Technical product information

Topic	Left - Multi Function Steering Wheel Switch (E440) DTC
Market area	Bentley: worldwide (2WBE)
Brand	Bentley
Transaction No.	2039769/2
Level	EH
Status	Approval
Release date

Figure 1

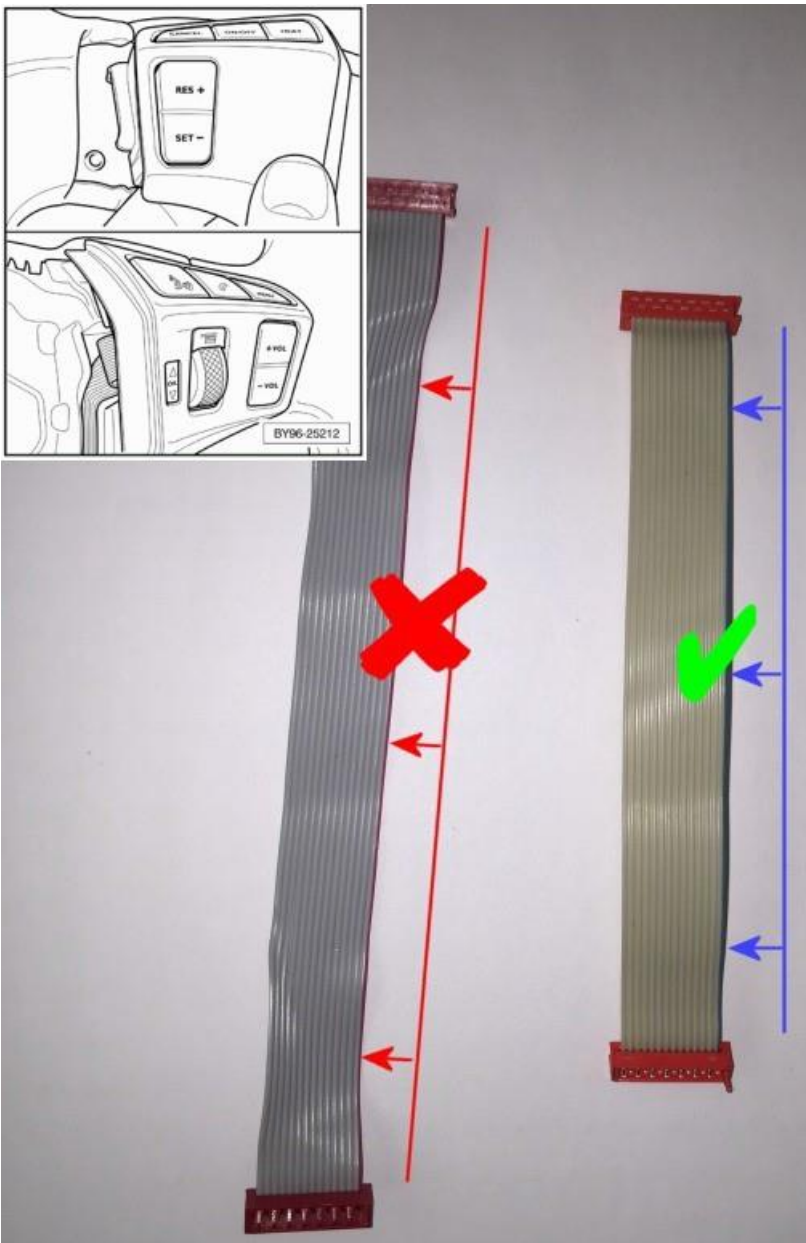
Inspect the ribbon cable connected to the ACC switch if the currently fitted cable has a red trace then fitting a new switch pack assembly will resolve the issue. Correct to tolerance switch assemblies are identified with a blue trace ribbon cable

Note: The switch is supplied as an assembly, two switches, ribbon cables and module fit all supplied parts
